HISTORIC AND DESIGN REVIEW COMMISSION

HDRC CASE NO: 2021-507
ADDRESS: 120 NOGALITOS ST
LEGAL DESCRIPTION: NCB 1011 BLK 1 LOT N IRR 86.67 FT OF A29
ZONING: C-2 CD, RIO-7E
CITY COUNCIL DIST.: 1
APPLICANT: Alvin Peters/AP Architects, LLC
OWNER: Leopoldo Chavarria/Southtown 120
TYPE OF WORK: Site improvements, site furnishings, exterior alterations
APPLICATION RECEIVED: October 01, 2021
60-DAY REVIEW: Not applicable due to City Council Emergency Orders
CASE MANAGER: Katie Totman

REQUEST:

The applicant is requesting a Certificate of Appropriateness for approval to perform site work and exterior alterations to an existing structure on the property.

new work
site plan

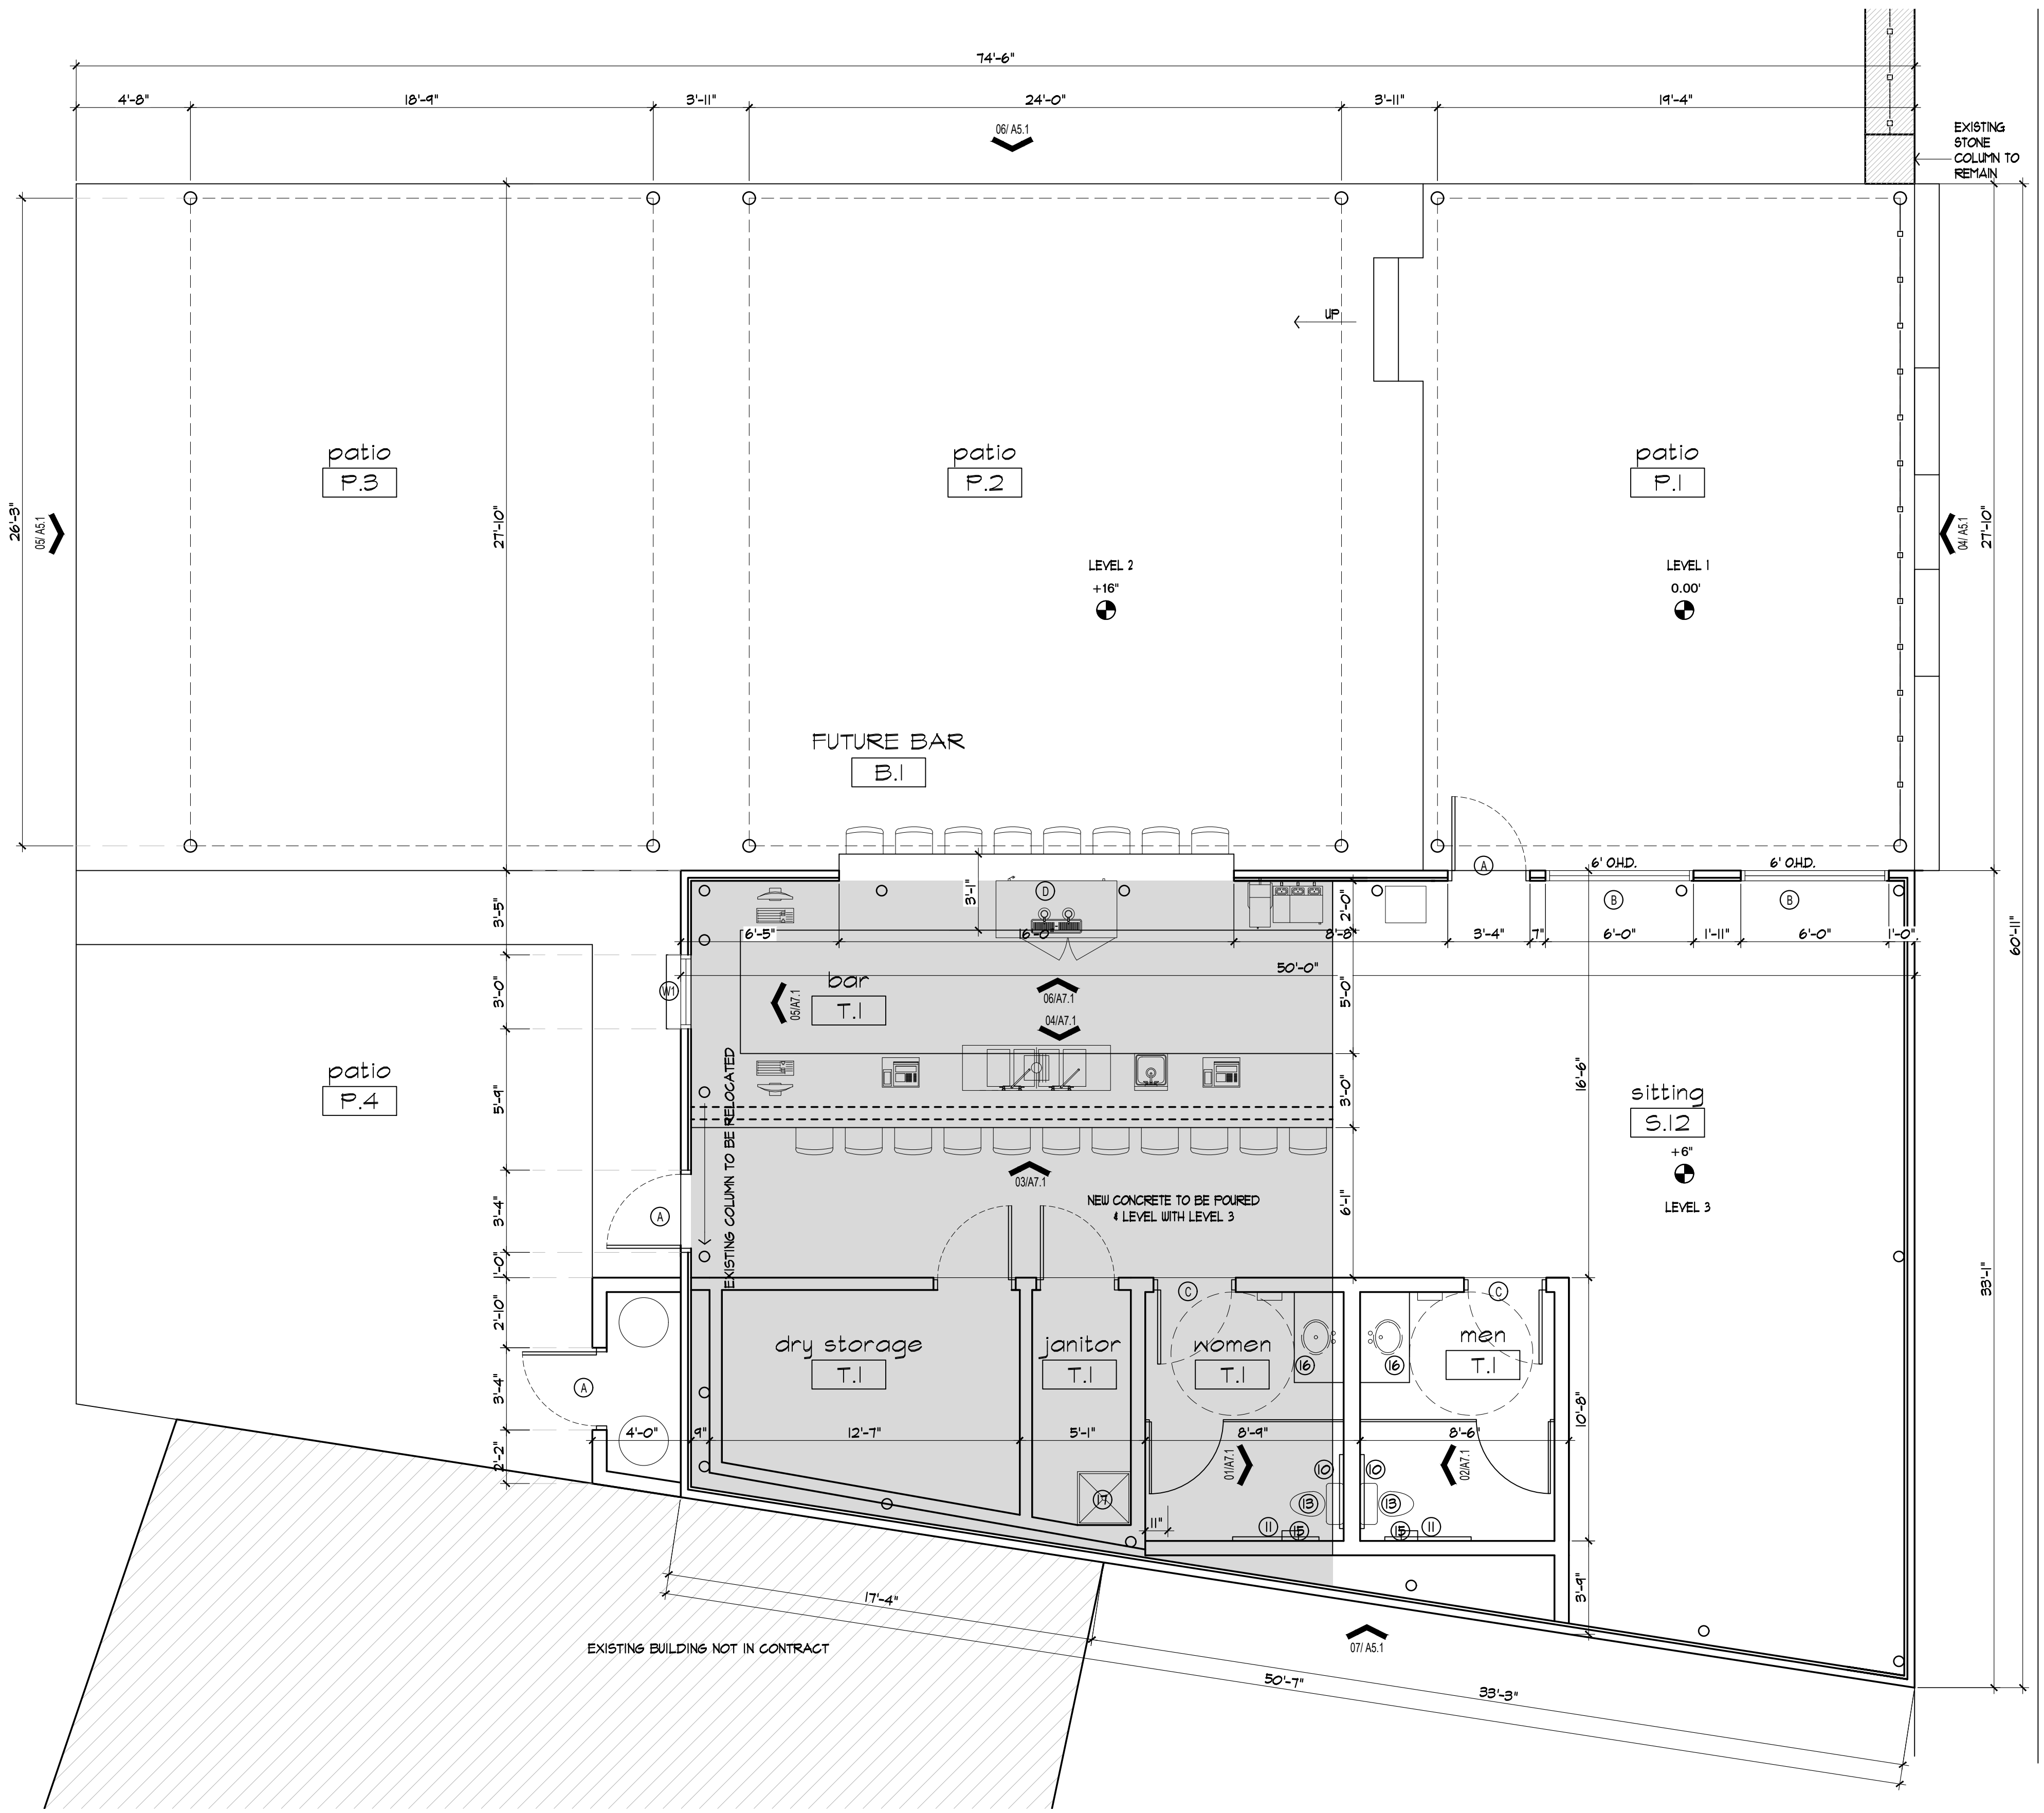
- c. **OUTDOOR SEATING/AWNINGS** – The applicant is proposing to add outdoor seating including tables and chairs on the site within the property lines and free-standing awnings adjacent to the existing metal building. Staff finds this to be consistent with the RIO/RIO-7 guidelines.

- e. FOOD TRUCKS – The applicant has noted the outdoor area modifications are proposed to accommodate several food trucks on the premises. The applicant is responsible for coordinating with Zoning staff regarding allowable use of the property to ensure the proposed use is permitted.
- f. ARCHAEOLOGY – The project shall comply with all federal, state, and local laws, rules, and regulations regarding archaeology, as applicable.

- i. That the overall height of the proposed fence be reduced to 6-feet to be consistent with the guidelines and UDC.
- ii. That the applicant provide staff with window and door specifications for review and approval prior to a COA being issued.
- iii. ARCHAEOLOGY – The project shall comply with all federal, state, and local laws, rules, and regulations regarding archaeology, as applicable.
